QUALITY ASSURANCE -- NON-CONFORMANCE REPORT

Location: Changxing Island, Shanghai, China **Report No:** NCR-000823
Prime Contractor: American Bridge/Fluor Enterprises, a JV **Date:** 02-Aug-2010
Submitting Contractor: Zhenhua Port Machinery Company, Ltd (ZPMC), Changxing Island **NCR #:** ZPMC-0785

Reference Description: Backing bar not continuous for Lift 13 member FB3217A

Job Name: SAS Superstructure
Document No: 05.03.06-000780

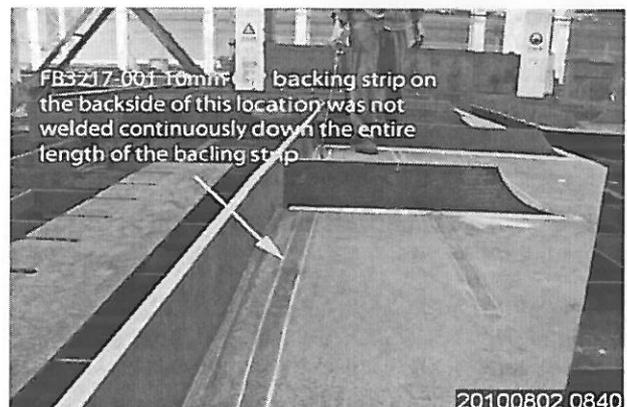
-Backing bar attached with intermittent tack welds.

-AWS requires the backing to be welded continuously for its entire length.

-The weld is identified as FB3217-100-136.

-The weld is a Complete Joint Penetration (CJP) T-joint, joining stiffener plate identified as X4495J to floor beam web plate identified as X4243A.

The backing has been attached to the base material by a continuous weld as required by Contract specifications and AWS D1.5 Section 3.13.4. NDT reports have been submitted verifying the weld in question meets Contract weld quality requirements. An internal NCR was issued in regards to this matter and the welder responsible was counseled on his work practices.
